File Code: 2810
Date: July 2, 2021

On June 9, 2021, Nicole Malandri, Lands and Mineral Staff, conducted an inspection of the Lombard #4 and #5 sites. At that time, the Lombard #5 adit had not been opened. The following items were discussed:

BAT GRATE ALTERNATIVES

Sincerely,

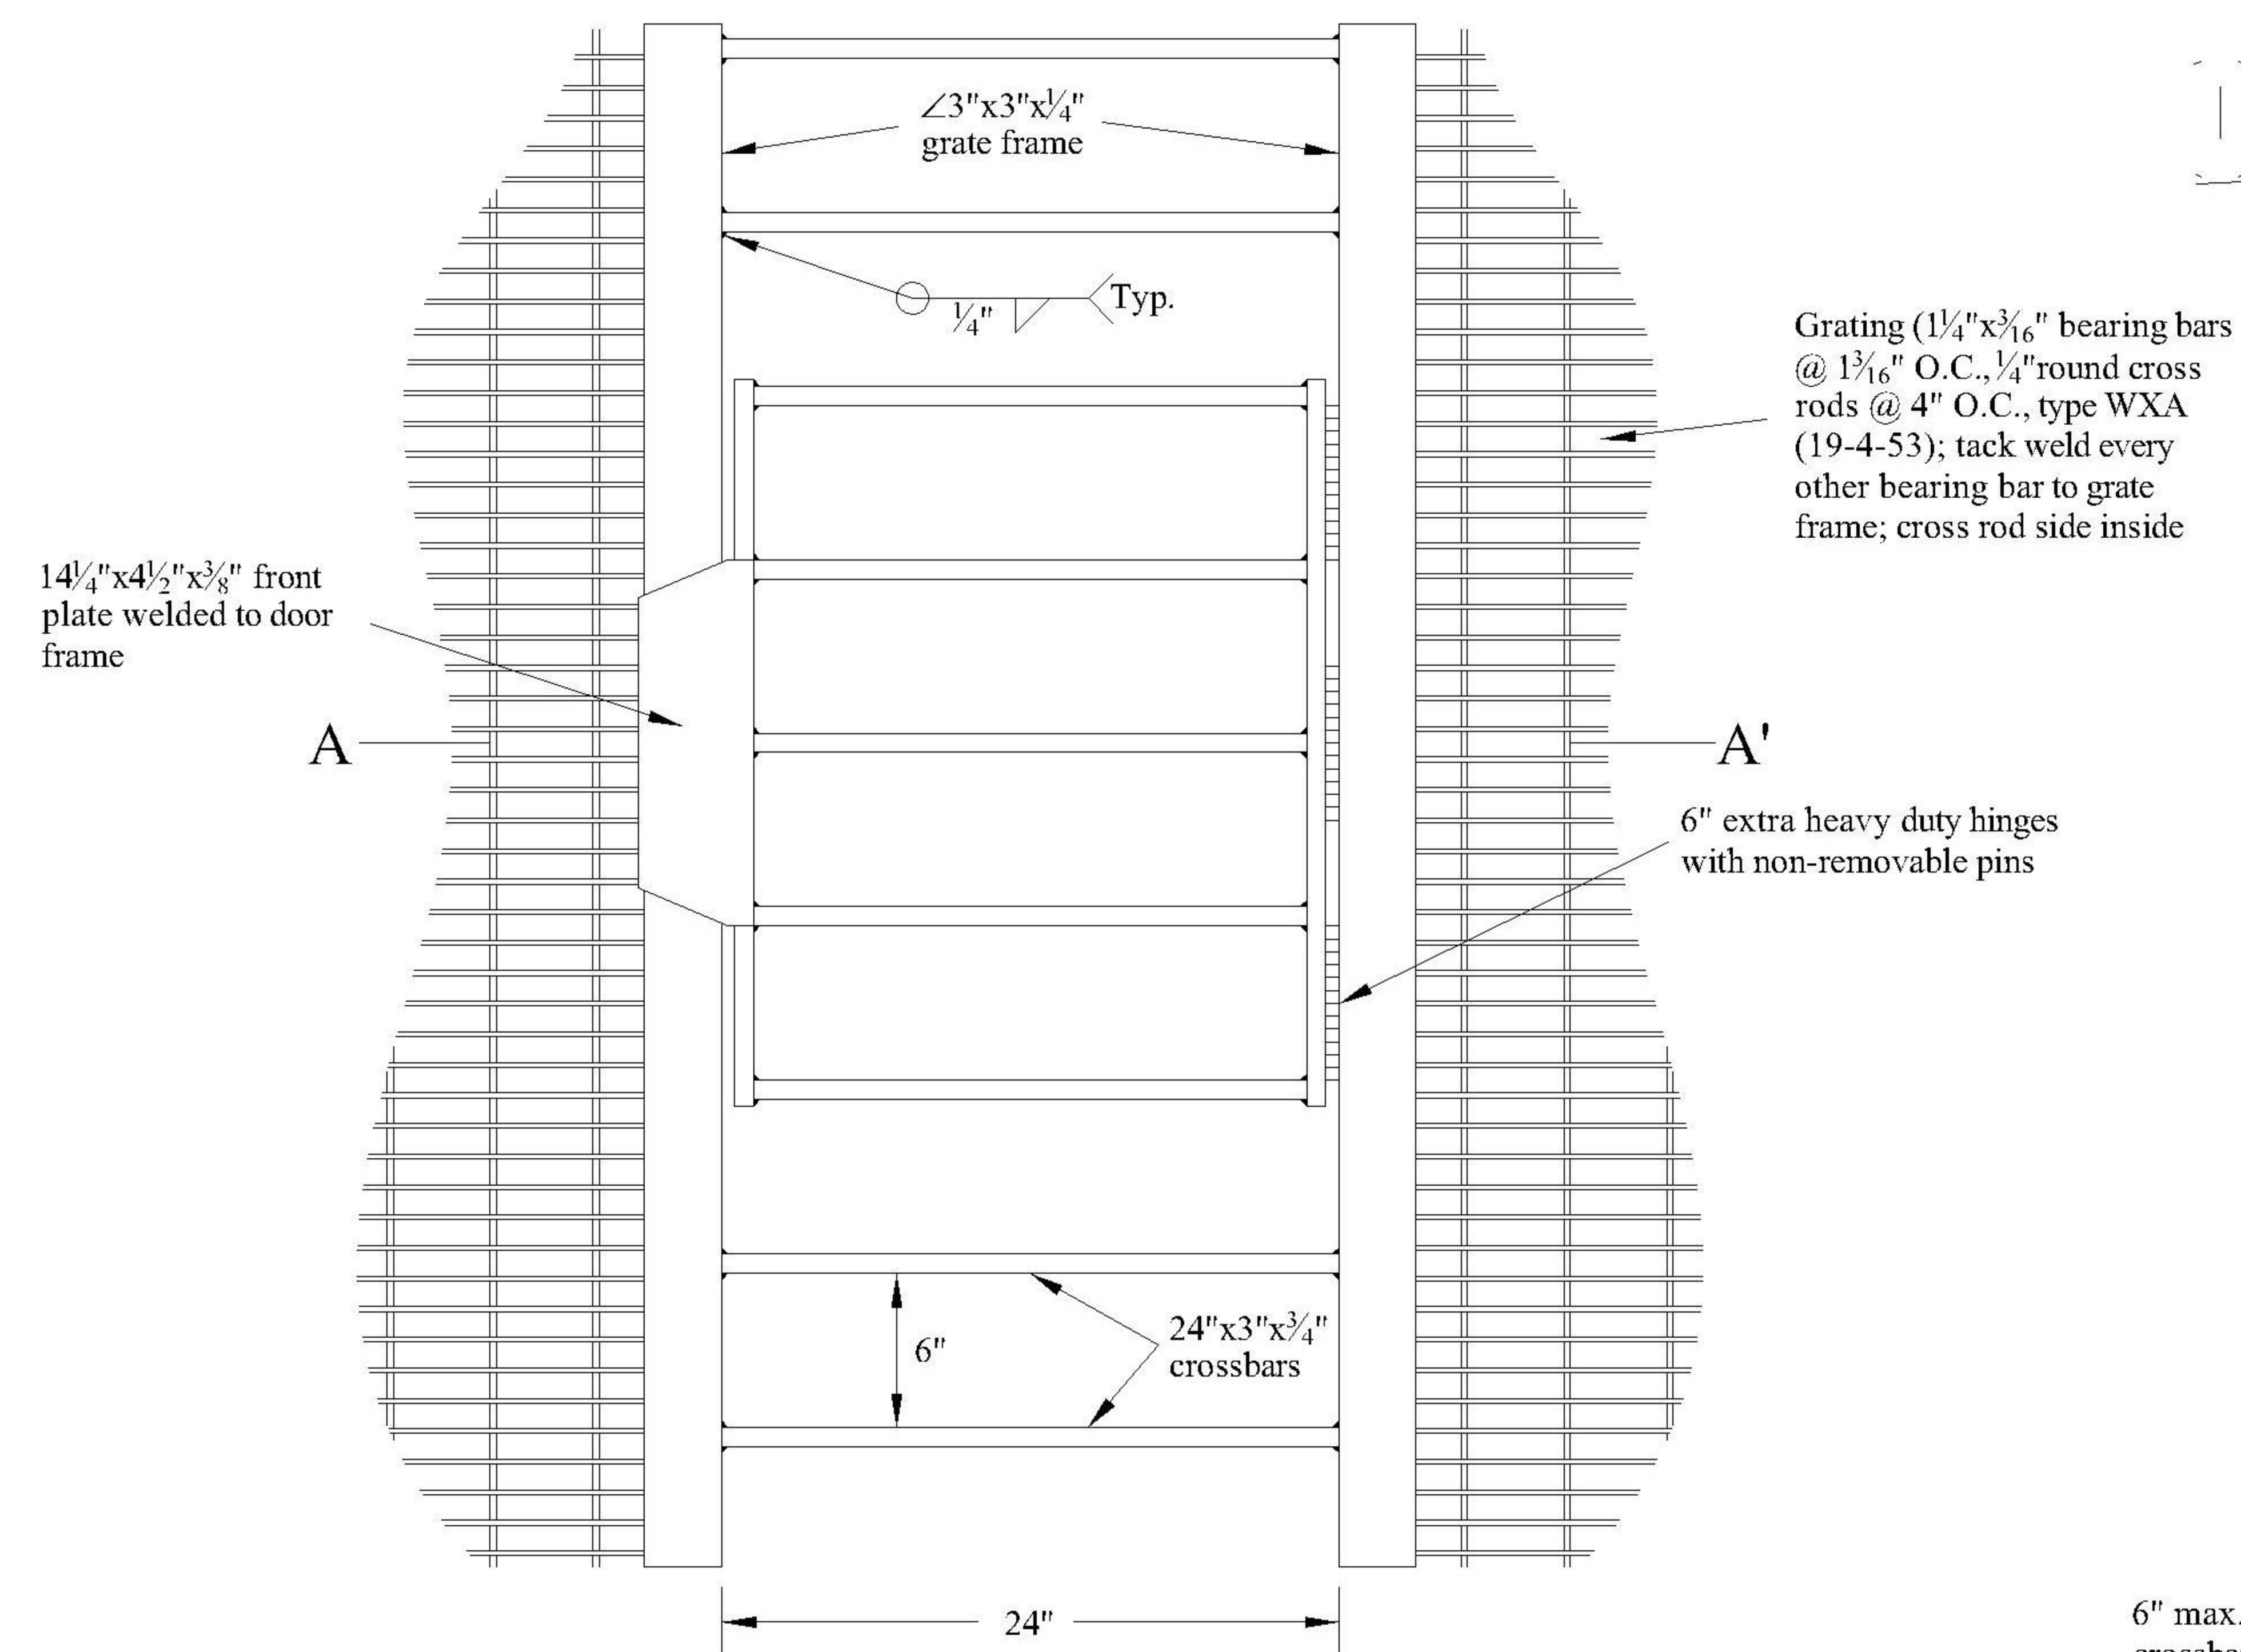
- There was a small rock fall at the Lombard #4 adit opening. When the adit is reopened a bat gate will need to be installed to replace the current adit closure. A sample design has been provided.
- All human waste must be transported off NFS land and disposed of in accordance with state and local regulations.
- The operator will use spill pads when pouring fuel or other petroleum products into tanks or other containers, to contain any spillage before it reaches the soil or water.
